Interactive comment on "Towards practical dynamic induction control of wind farms: analysis of optimally controlled wind-farm boundary layers and sinusoidal induction control of first-row turbines" *by* Wim Munters and Johan Meyers

Received and published: 23 May 2018

Fig. 1. Disk-averaged axial velocity upstream of the first-row turbines for column 1 and column 2 in Figure 2 of the manuscript. Vertical dotted lines demarcate the optimization window boundaries.

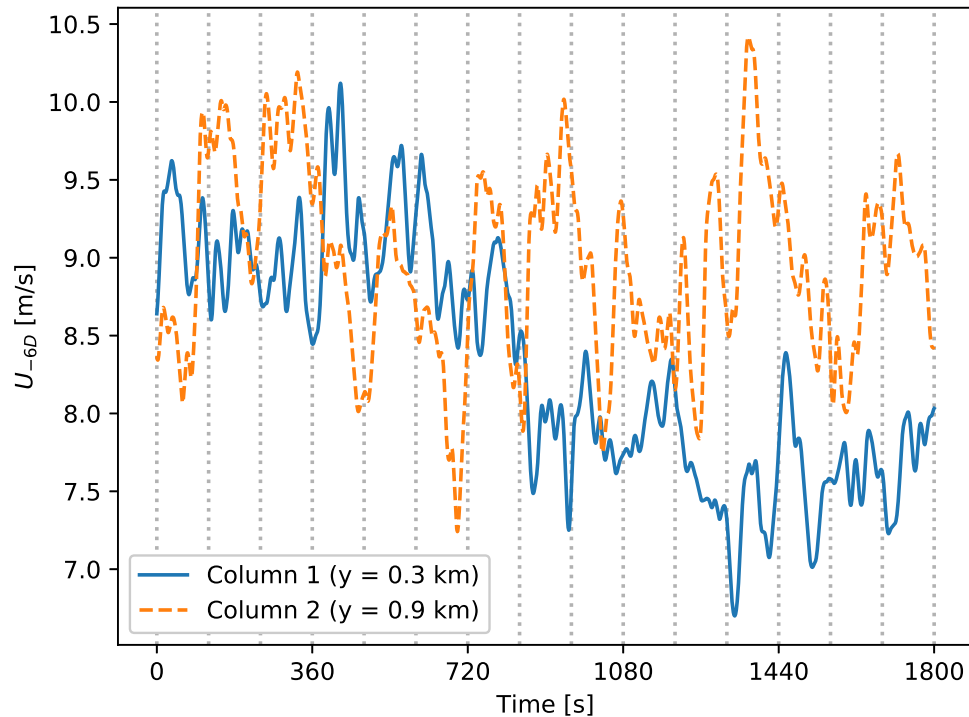
5. Reviewer: *On page 13, line 13, "the presence of the flow invariant features of the control signals" needs further justification as Figure 11 would also depend on how variant the flow features are in the simulations. That should include both the spatial and temporal variance within the 30-min window. As far as the field measurements are concerned, high spatial and temporal correlations are observed. For the former, Figure 2 gives a brief idea about the wind speed range between the columns, that can be referred here. For the latter, time series or relevant temporal statistics can be presented to assess the randomness and strengthen the hypothesis.*

Response: We thank the reviewer for this useful comment. We have quantified spatial variance (between columns) as well as temporal variance (between time windows) of the flow field by investigating the correlation between the incoming disk-averaged velocity at $6D$ upstream of the first-row turbines (illustrated for two columns of the wind farm in Figure 1 of the current document). As shown in the Figure, there is considerable variation of the incoming velocities between columns and between time windows, and velocity fluctuations seem qualitatively uncorrelated. To keep the discussion in the manuscript concise, we do not include the figure below but instead report the average Pearson correlation coefficient between the incoming velocity fluctuations in different columns (for the full time horizon) and in different time windows (averaged over all

columns), with low values of 0.12 and 0.07 respectively.

We have incorporated this in the revised manuscript as follows (p. 14, line 4):

" ... the column swap is performed in 2 random independent ways. **The variability of flow conditions for different columns can be qualitatively observed in Figure 2. To further strengthen the hypothesis of the current experiment, we verified that the correlation between flow conditions in different columns is small, i.e. with an average Pearson correlation coefficient of 0.12 between columns for the incoming velocity fluctuations $6D$ upstream of the first row.** "
